November 5, 2018

RE: **Lot 3 Block 2, Volcano Cliffs, Unit 22, SAD 228**
8016 Canoncito NW
Grading and Drainage Plan
Engineers Stamp Date 10/29/18 (D10D003C3)

James D. Hughes, P.E.
Principal Engineer, Hydrology
Planning Department

ENGINEER'S SEAL	LOT3 UN2 BLK22 VOLCANO CLIFFS SANCHEZ RESIDENCE	DRAWN BY DEM
	GRADING AND DRAINAGE PLAN	DATE 10-27-18
DAVID SOULE P.E. #14522	 1608 CENTRAL AVENUE SE SUITE 201 ALBUQUERQUE, NM 87106 (505) 972-0899	LOT 3 UN 2 BLK22 VOLCANO CLIFFS.DWG
		SHEET # C1
		JOB #

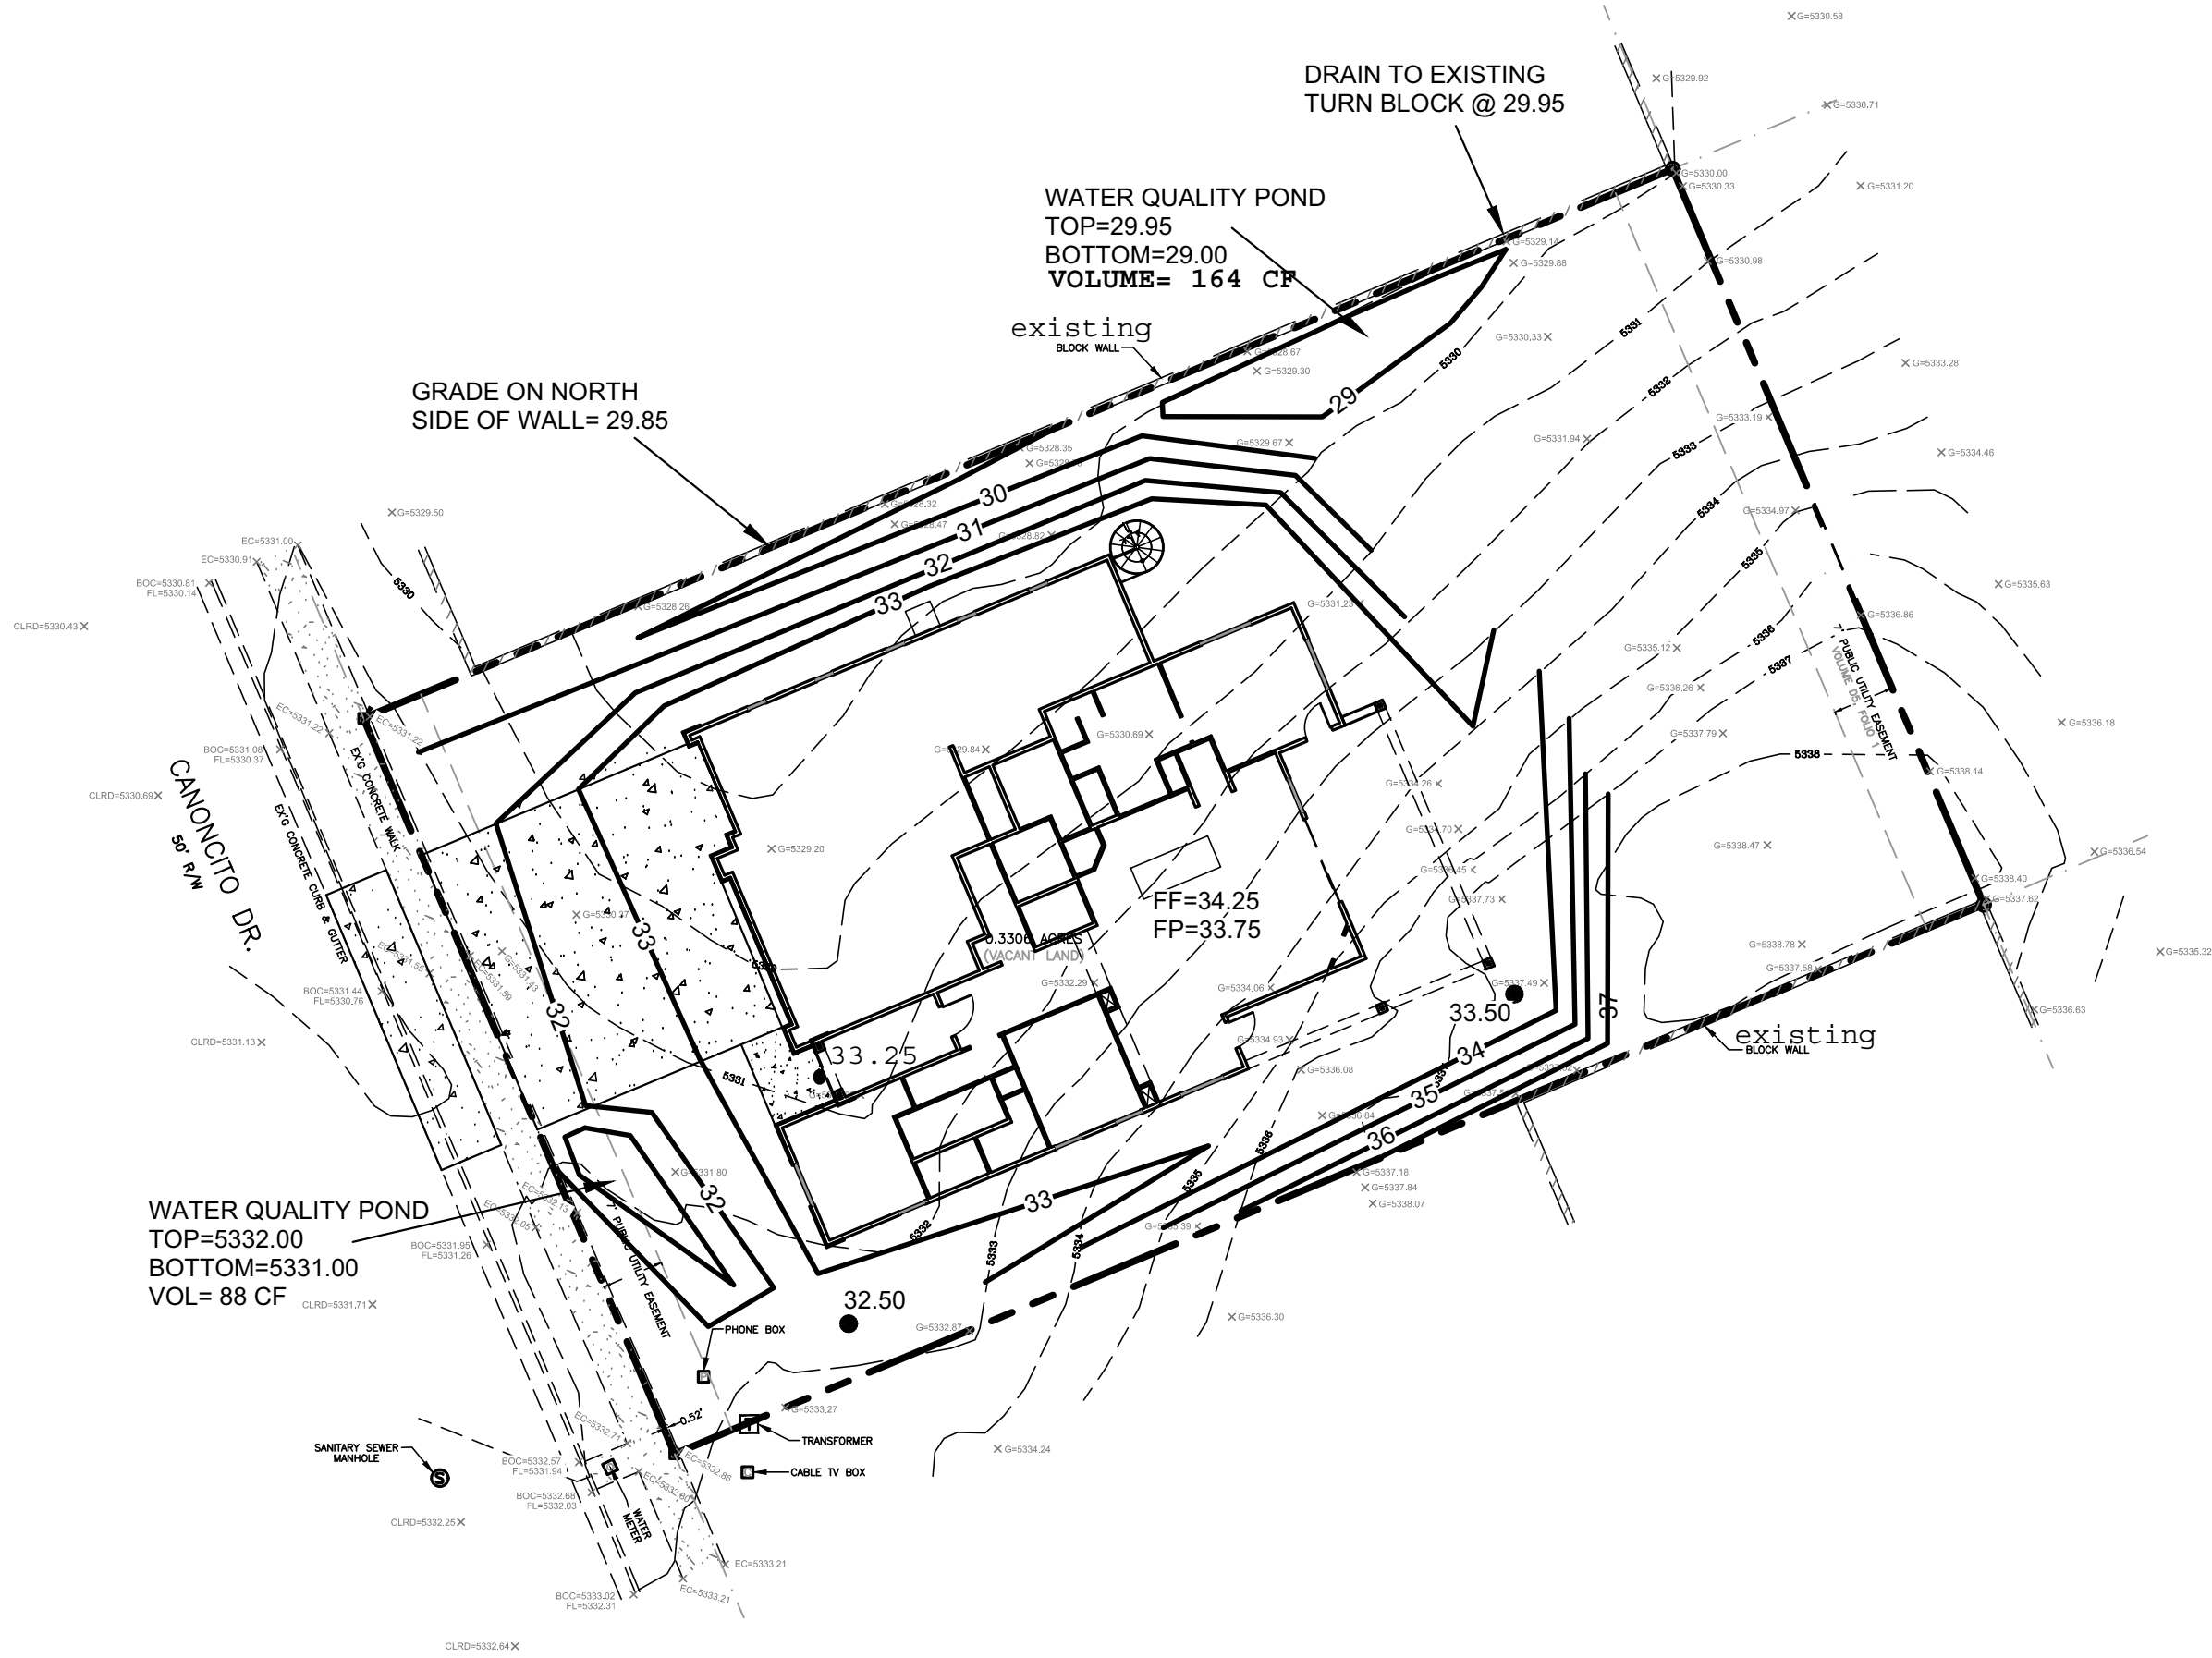
Based upon the information provided in your submittal received 11/1/18, this plan is approved for Grading Permit.

Prior to Building permit approval a Pad Certification will be required, provided by the Engineer or a registered Land Surveyor.

Reiterate to the Owner/Contractor that a separate permit for a garden/retaining wall must be obtained with the approved G&D plan and Pad Certification.

Prior to Certificate of Occupancy release, Engineer Certification per the DPM checklist is required.
